POTENTIAL FINDING REPORT  
SONGS 2&3 SEISMIC DESIGN VERIFICATION

PFR NO. 2408 PFR-F041

2408 PFR NO. F049

ATTACHMENT K4 of 5  
 2-8-PFR F092  
 CALC. NO. 10017-003  
 DATE 3/17/00  
 CHECKED GP  
 DATE 3/17/00  
 JOB NO. 10017-003  
 SHEET 11 OF 32 SHEETS

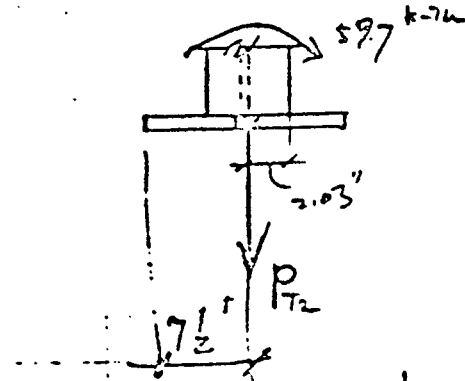
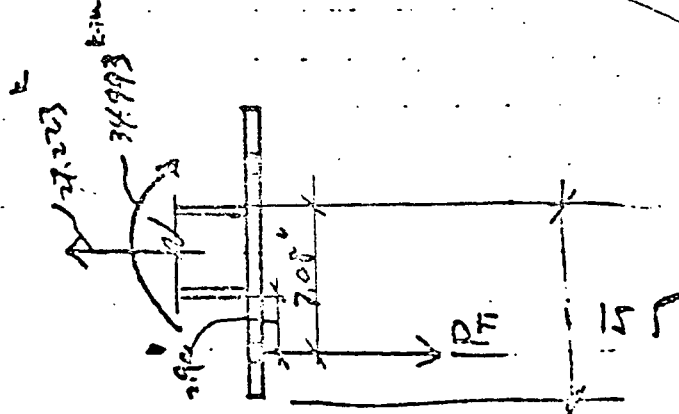
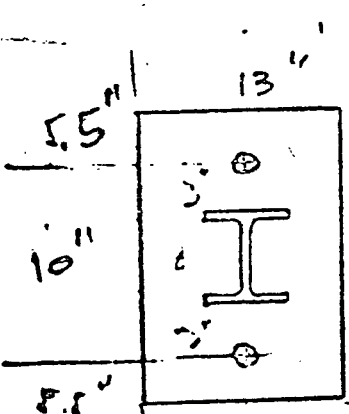
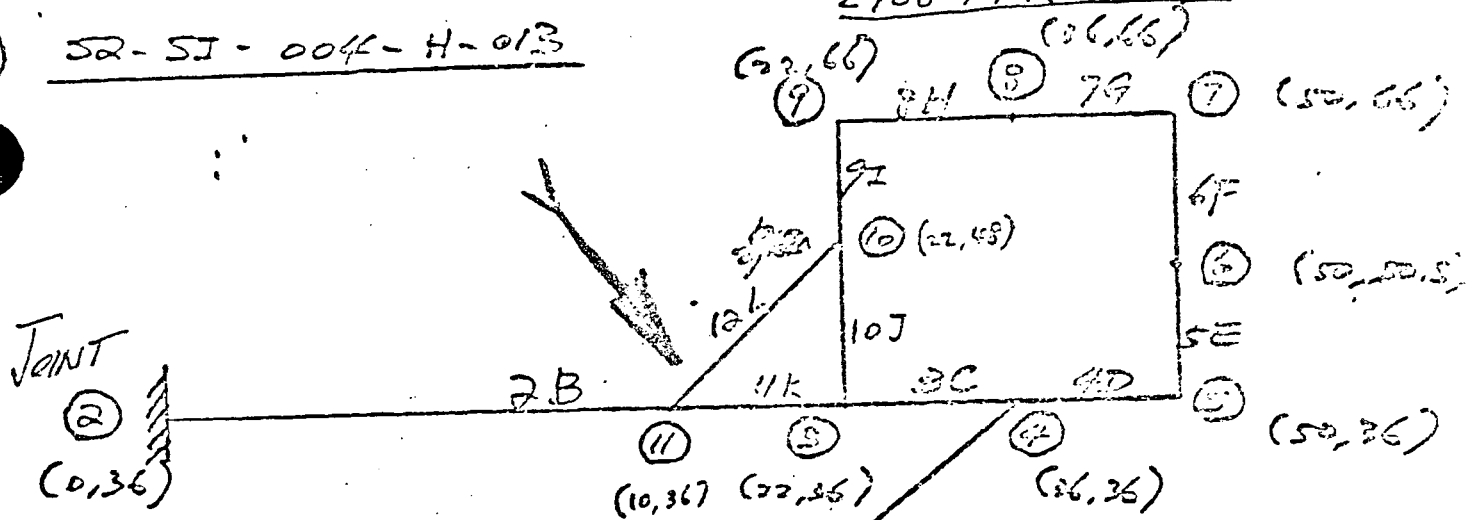
WELD OF (B) TO (A)

2408 - PFR - F102 ATTACHMENT 1

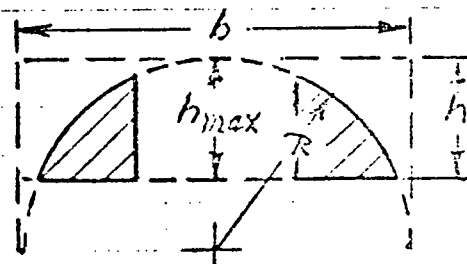
THE ACTUAL TENSION AREA IS AS SHOWN SHADED UNDER ITEM 3) BELOW. IT IS NOT CLEAR, IF THE  $L \times t$  VALUE USED IS CONSERVATIVE.

- 2) THE AREA SHEAR ( $41.12 \text{ in}^2/\text{TONGUE}$ ) CALCULATED IN REF. 3 APPEARS TO BE TOO LARGE. A CONVENTIONAL SHEAR AREA CALCULATION YIELDS  $24.54 \text{ in}^2/\text{TONGUE}$ . IF FOR CONSISTENCY AN EFFECTIVE  $t$  OF  $1.208"$  IS USED, THE CALCULATION WILL YIELD A SHEAR AREA OF  $4.52 \text{ in}^2/\text{TONGUE}$ . SEE ATTACHMENT 3.

- 3) QUANTITIES  $A_1$  AND  $I_1$  ARE UNCONSERVATIVELY BASED ON A RECTANGULAR SECTION  $h \times b = 4.14" \times 12.980"$ . THE ACTUAL SECTION IS A CIRCULAR SEGMENT WITH  $R = 6.49"$  AND  $h_{\text{max}} = 4.14"$  LESS THE  $5.252"$  CENTER HOLE FOR THE BUSHING.
